Houston Lighting & Power South Texas Project Electric Generating Station P. O. Box 289 Wadsworth, Texas 77483

June 26, 1997  
ST-HL-AE-5679  
File No.: G02.05  
10CFR50.54(a)

South Texas Project  
Unit 1 and Unit 2  
Docket No. STN 50-498 and STN 50-499  
Response to Request For Additional Information of June 13, 1997  
Regarding the South Texas Project's Graded Quality Assurance Program

Response To NRC Request for Additional Information of June 10, 1997 on the Graded  
Quality Assurance Program

GRADED QUALITY ASSURANCE PROCESS FLOWCHART

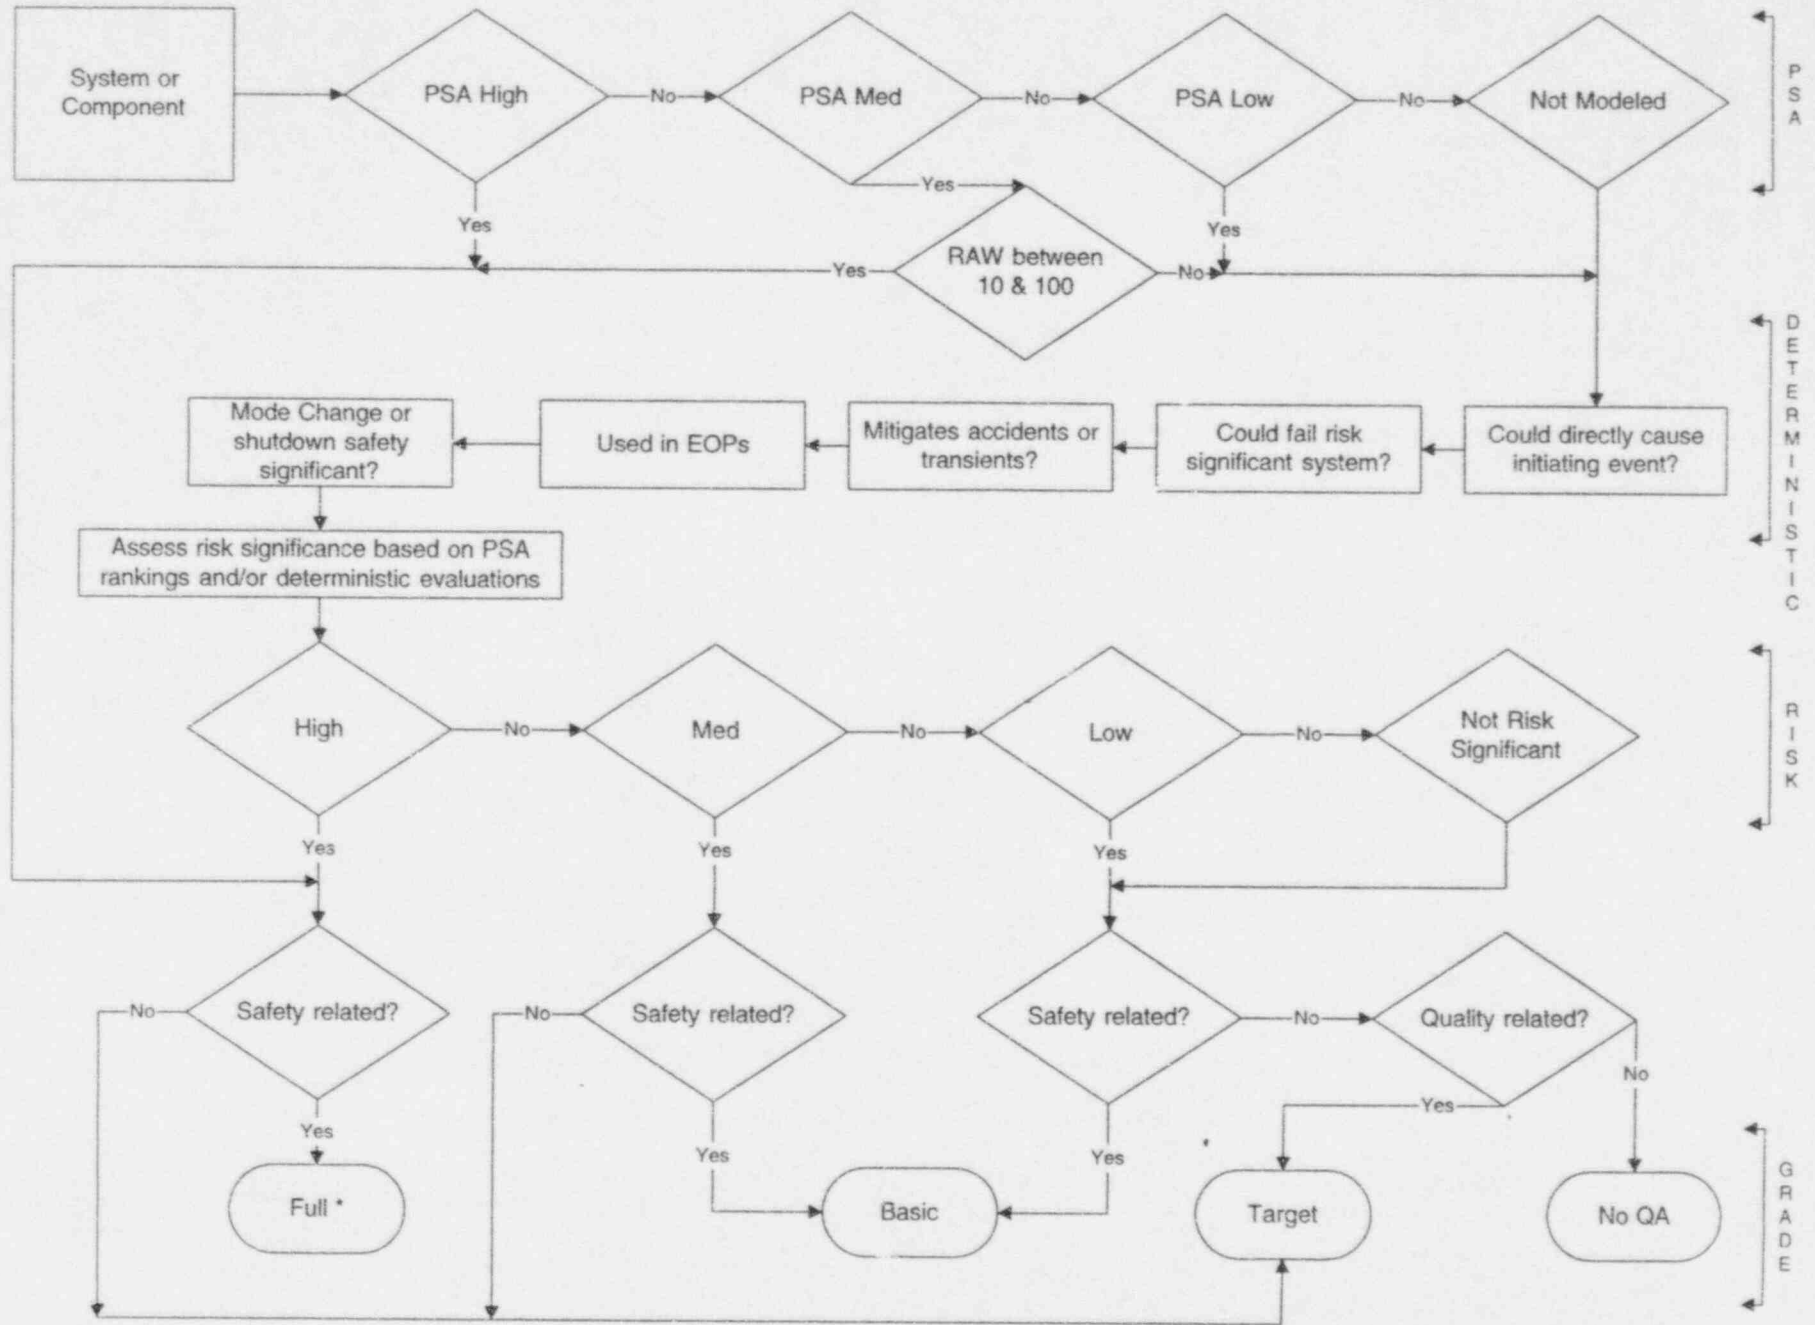
*During the May 5-8, 1997, site visit NRC expressed concern that placing components with a risk achievement worth (RAW) greater than 10 but less than 100 in the Basic program may be inappropriate. NRC requested that HL&P identify this population of components in the QA program description, and describe how specific QA controls would be assigned to the components' critical attributes. NRC has not found a satisfactory resolution to this concern in the May 21, 1997, revised submittal. NRC requests that STP change the QA program description to:*

- *include a clear definition of the population of components in question. These components are currently categorized as medium safety-significant which provides no distinction from other medium safety-significant populations. NRC is willing to consider the acceptability of a definition of this population which does not include numerical guidelines in the OQAP, but the basic attributes of the population (e.g., high reliability yet a high impact on risk if problems develop) must be clearly described.*

- *provide a description of how QA controls will be assigned to the critical attributes of this population of components. As discussed, NRC does not find that simple application of Basic program controls is sufficient. Nor does NRC find that explicit consideration by the working group and expert panel of the assigned controls is sufficient. NRC is willing to consider the acceptability of assigning Full program controls to those critical component attributes which cause the component to belong to this population.*

*Another alternative is to simply assign these components to the high safety-significant category based on the sensitivity of plant risk on their performance and place them in the FULL program. Other alternatives may also be suggested.*

The Comprehensive Risk Management Procedure, OPGP02-ZA-0003 Addendum 2 will be revised to incorporate the flowchart provided in Attachment 2 which identifies the Probabilistic Risk Importance thresholds used for Graded Quality Assurance component classifications.

\* SR Components with a RAW between 10 and 100 are to have Full QA applied to the critical attributes associated with that RAW

PROBABILISTIC RISK IMPORTANCE THRESHOLD FOR INPUT TO  
GRADED QUALITY ASSURANCE COMPONENT CLASSIFICATIONS

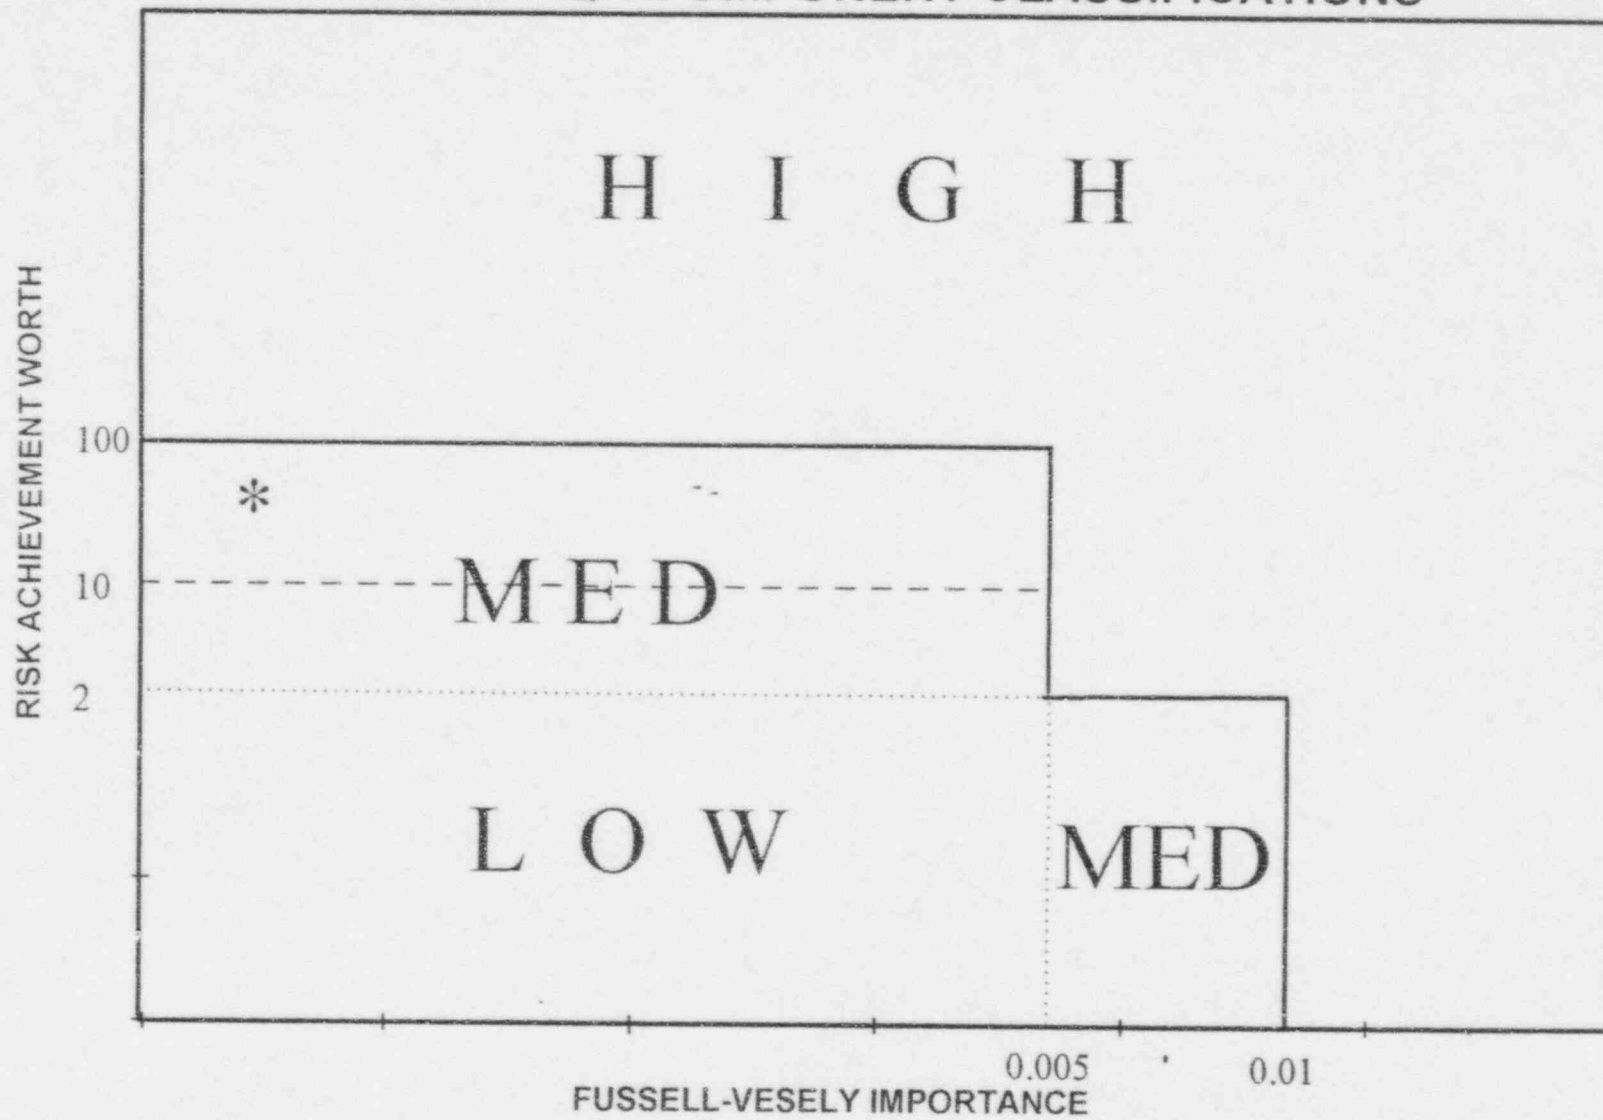
12. *Although not discussed during the May 5-8, 1997, site visit, discussion among the NRC on the acceptability of your proposed categorization scheme has raise the question of why a high Fussell-Vesely (FV) value should not also lead to a high-safety-significant categorization regardless of the RAW. Please provide your position with respect to this issue.*

- ✦ Components with a risk achievement worth greater than 100 or a Fussell-Vesely importance greater than 0.01 are to be placed in the Full QA Program.
- ✦ Components with a risk achievement worth greater than 10 but less than 100 are to have full QA controls specifically placed on those critical attributes which cause the components to have a high risk achievement worth.

A graphical representation of the Probabilistic Risk Importance thresholds for input to the Graded Quality Assurance component classifications is provided in Attachment 3.

As noted in the response to item #11, the categorization process has been revised to reflect a threshold for the Fussell-Vesely component importance at 0.01. The basis for risk importance threshold is provided in Attachment 4.

\* Full Program is applied to critical attributes associated with the high Risk Achievement Worth
